RDCC APPEAL CASE SHEET

CASE: 2014-056362PR

ADDRESS: 903 Ethel Street

A waiver request (2014-056362 PR) was submitted to the Residential Design and Compatibility Commission (RDCC) to increase the maximum allowable floor-to-area ratio (FAR) for the single-family residence located at 903 Ethel Street (Zilker). Under Subchapter F (McMansion) the FAR of single-family residences are limited to 0.4 to 1, and certain parking areas are excluded from the calculation.

1 NORTH ELEVATION AT CARPORT
SCALE: 1/8" = 1'-0"

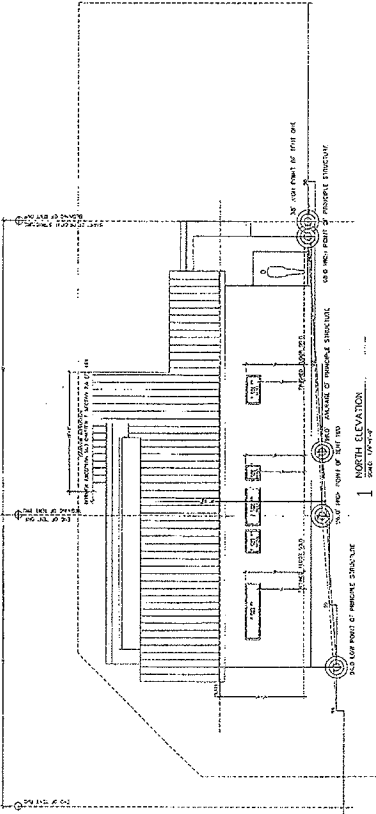
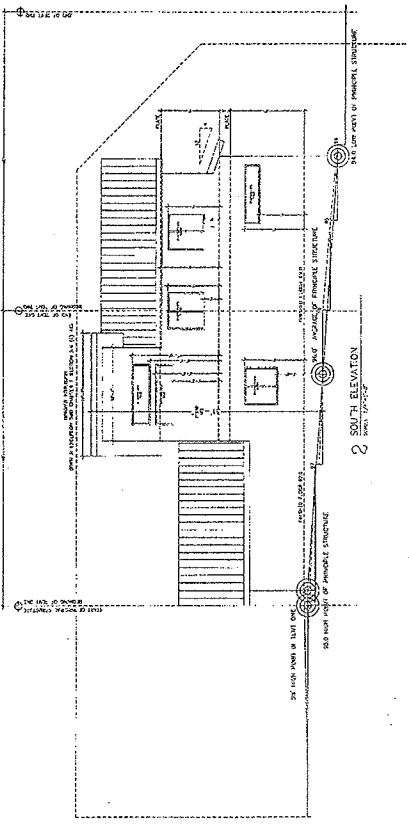
Neither opening for the carport meets the 80% requirement (contrary to what the owner has implied in various places in the waiver request). The builder is required to submit accurate information, so the City staff probably assumed the 80% opening requirement was met without checking further. However, this assumption was not correct as the attached figure shows. There is some question as to whether the top of the wall plate means the wall plate upon which the carport ceiling rests or the wall plate upon which the roof trusses rest. However, in either case, the openings do not meet the 80% opening requirement.
